ADDENDUM NO. 3

Project: Beatrice Middle School Renovations

Project No.: L13017

Date: 5/17/2013

L14 Lincoln Elementary - Multi-Purpose Room - Lighting
 SCALE: 1/8" = 1'-0"

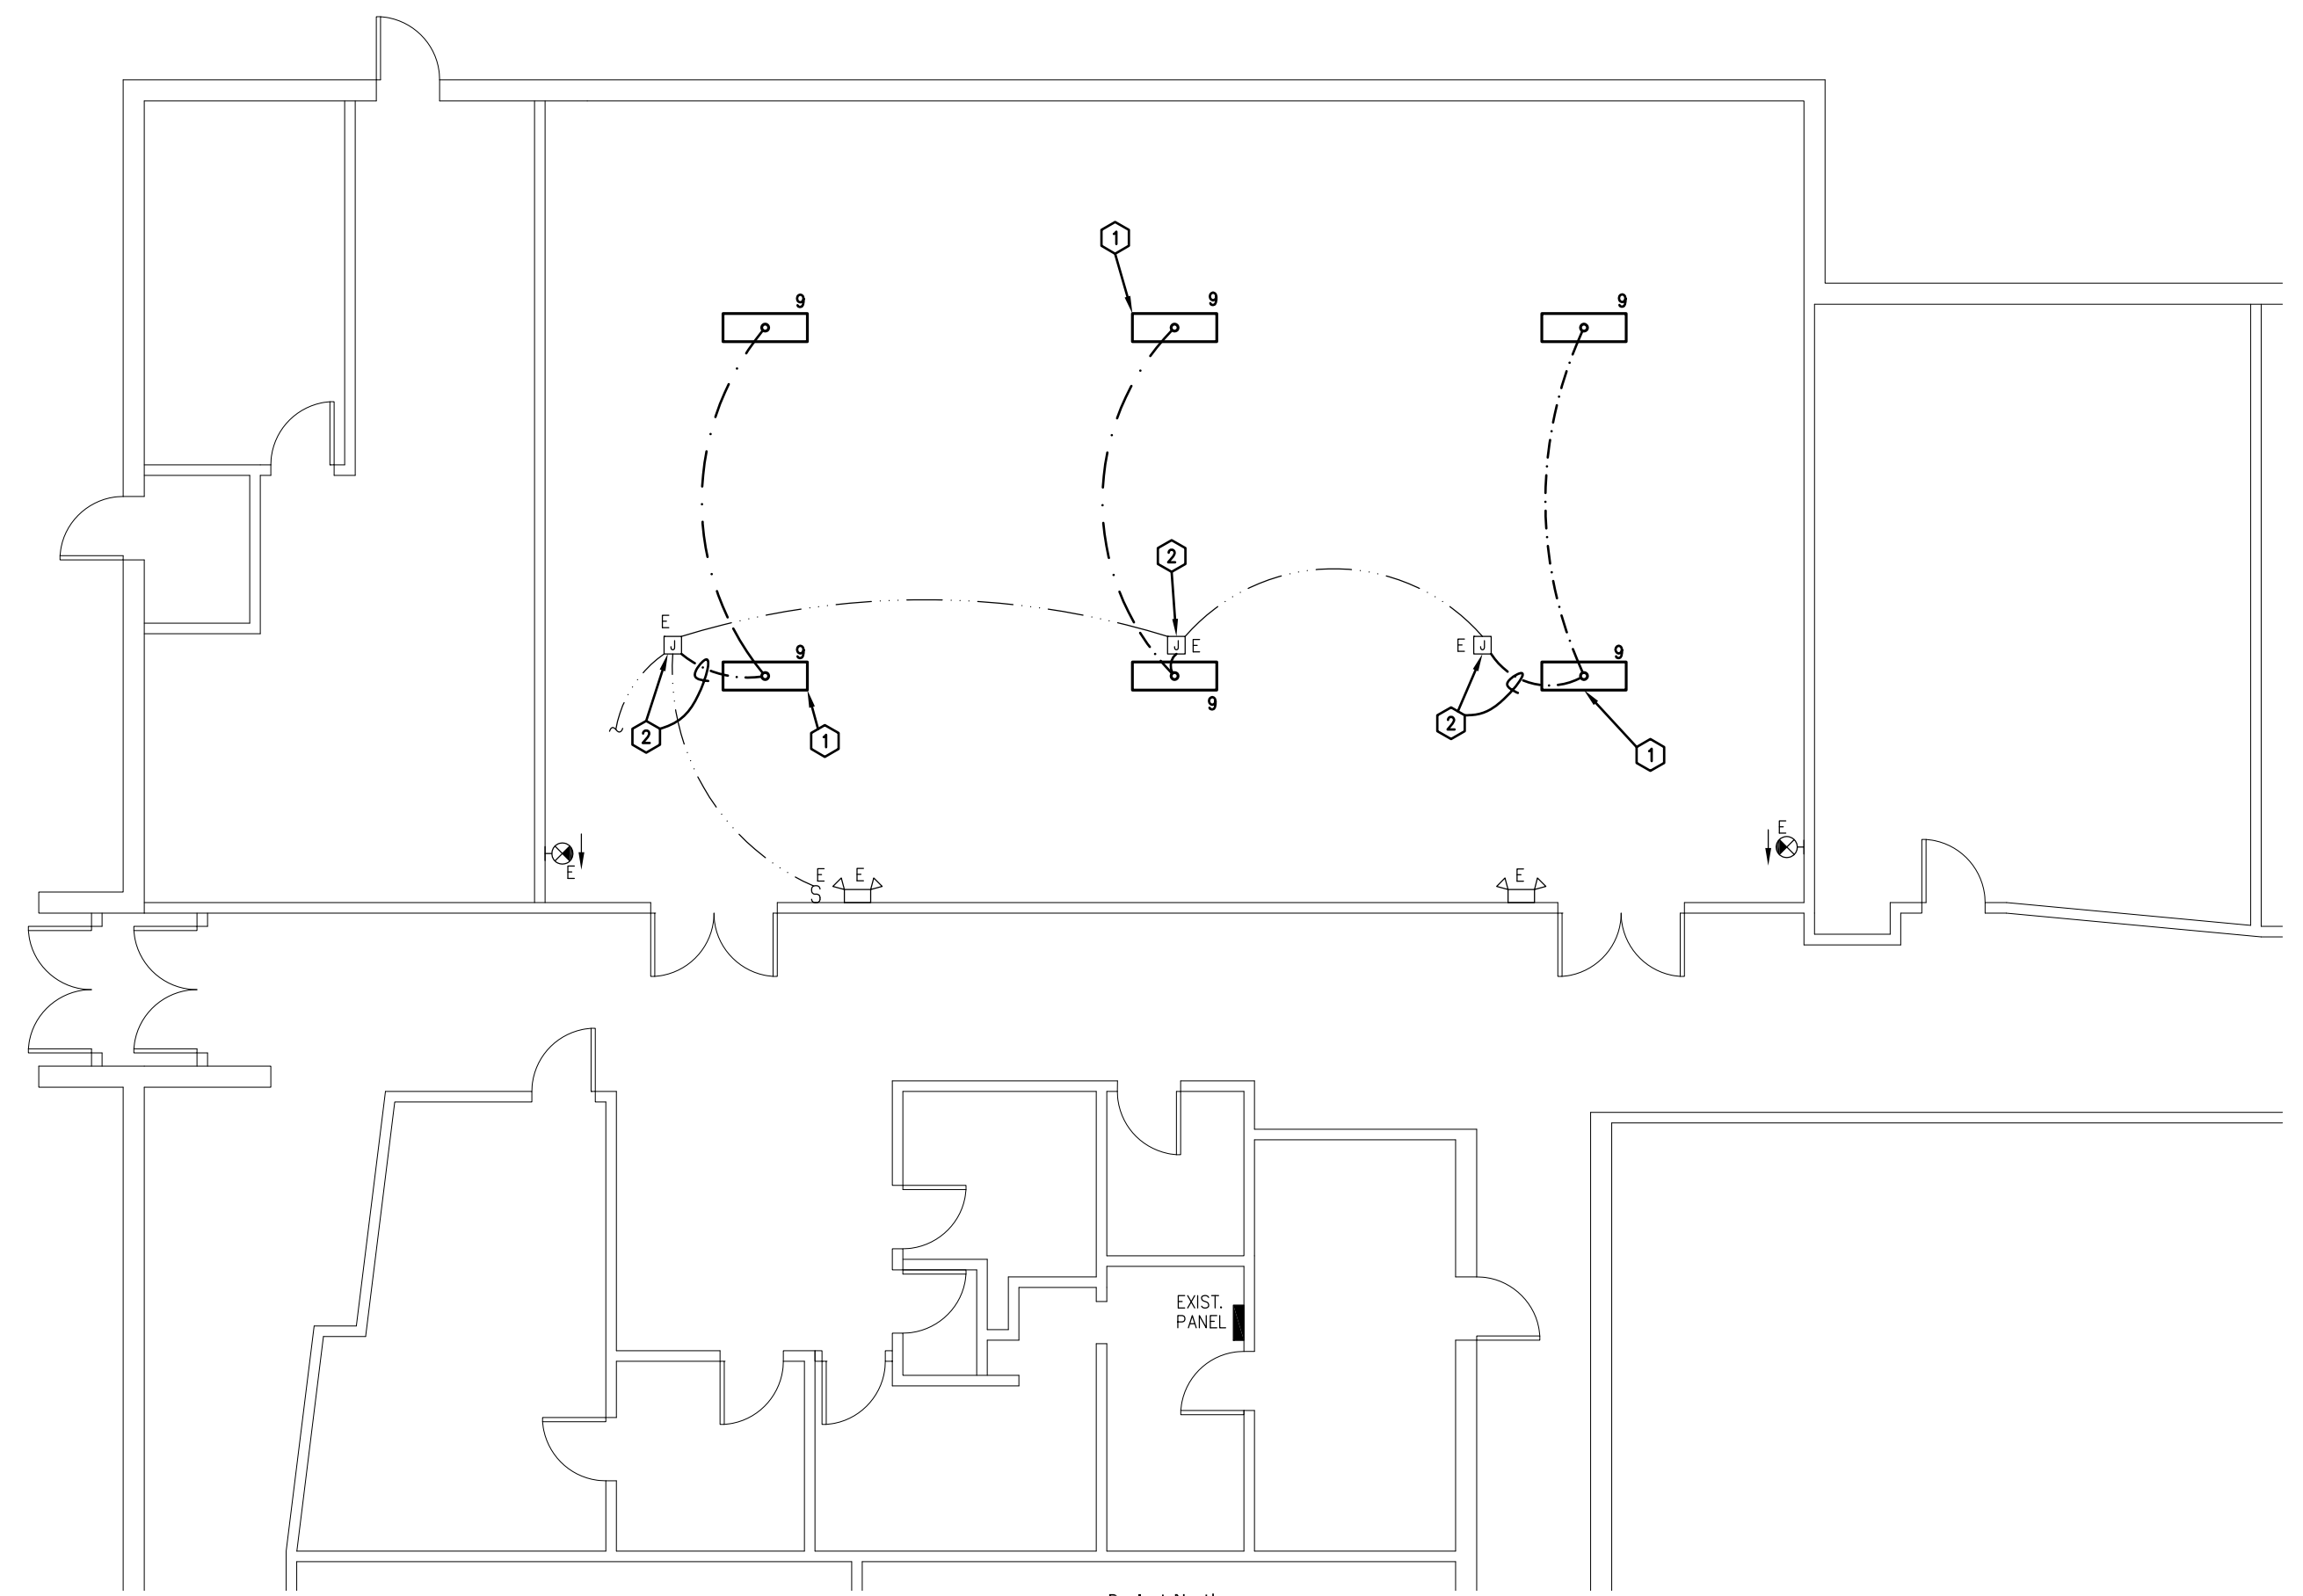
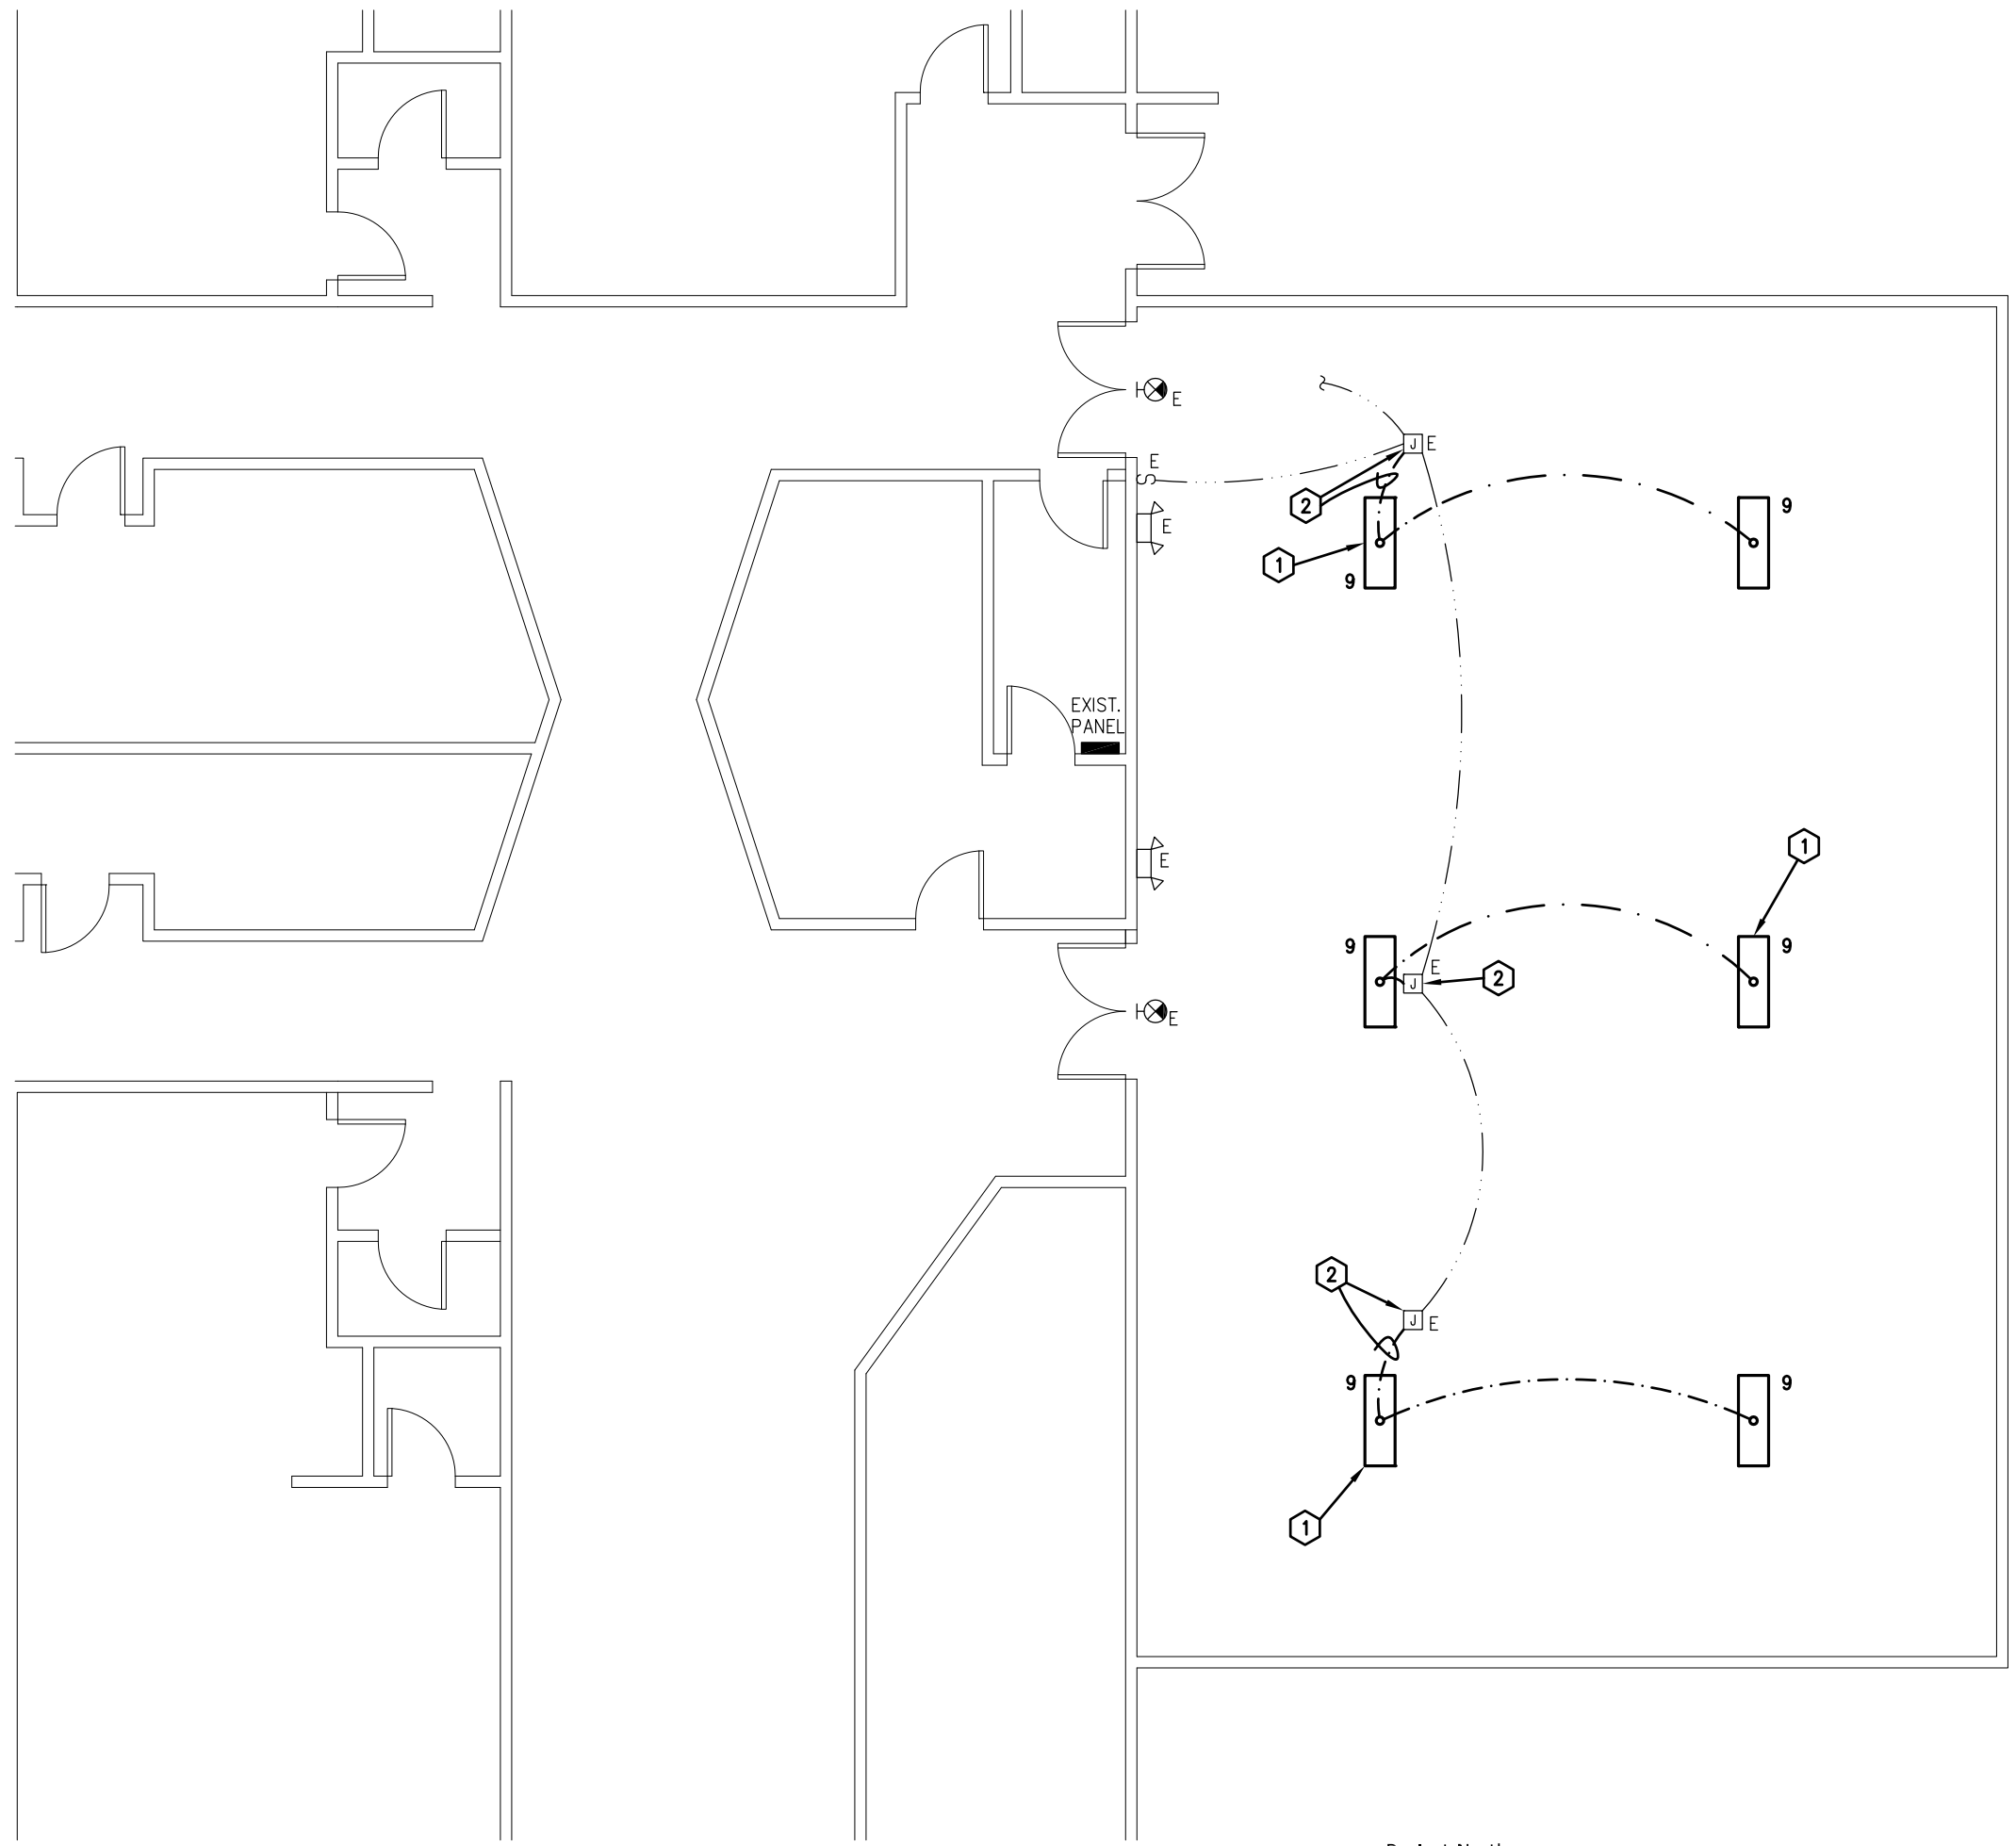
1. See attached drawing E1.3 indicating the removal and replacement of lighting at the Multi-Purpose Rooms at Paddock Lane, Stoddard, Lincoln and Cedar Elementary Schools.
 - A. This work shall be bid as Alternate No. 1.

- 1 SHEET NOTES**
- REMOVE AND REPLACE EXISTING LIGHT FIXTURE WITH NEW LIGHT FIXTURE SHOWN.
 - EXISTING JUNCTION BOX AND LIGHTING CIRCUIT TO REMAIN. EXTEND LIGHTING CIRCUIT TO NEW LIGHT FIXTURES AS REQUIRED.
